UNITED STATES ENVIRONMENTAL PROTECTION AGENCY  
REGION IX  
75 Hawthorne Street  
San Francisco, CA

Thank you for providing for review the *Draft Work Plan, Radiological Survey and Sampling*, Former Hunters Point Naval Shipyard, San Francisco, California ("Work Plan"), February 2018. The U.S. Environmental Protection Agency (EPA) reviewed this report in detail with a technical team including national experts in health physics, geology, and statistics.

### **EPA Review of the Draft Work Plan Radiological Survey and Sampling Former Hunters Point Naval Shipyard, San Francisco, California, February 2018**

Figure 1. Distribution of Ra-226 Off-Site Laboratory Measurements in picocuries per gram (pCi/g) in Background Reference Areas

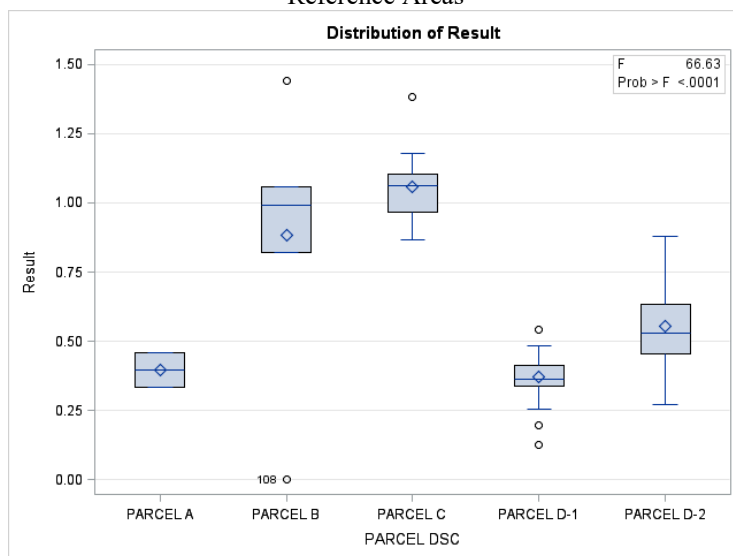
Reviewer Comments: In order to meet MARSSIM and NRC criteria, sample sizes for background reference areas should be computed per independent interval, surface soils and subsurface soils, not across both. Additionally, it is clear from historical data provided by the Navy and collected at the background reference areas in Parcels A, B, C, D-1, and D-2, that variability is not consistent across the five areas for off-site laboratory Ra-226 measurements (Figure 1).

Recommendations: Given the differences in variability and mean/median concentrations for Ra-226 as demonstrated in Figure 1, it is recommended that background reference area sample data should not be combined across the five areas, but rather background reference areas should be established per Parcel with sample sizes computed based on the variability within each background reference area per independent interval (surface soils and subsurface soils).

Sample sizes should be justified with detailed statistical analyses and explanations of how inputs to the computations were derived, including specifics of how estimates of variability were obtained (e.g., what data was included in the calculation, how and where the data was collected, what assumptions were made). If measurements from multiple background reference areas will be combined, the results of a comparative analysis such as an Analysis of Variance (ANOVA) or non-parametric equivalent (Kruskal-Wallis Test) must be documented to support combining the areas. These comparative tests will establish if there is a statistically significant difference between Ra-226 and Cs-137 in the background reference areas at a specified confidence-level.
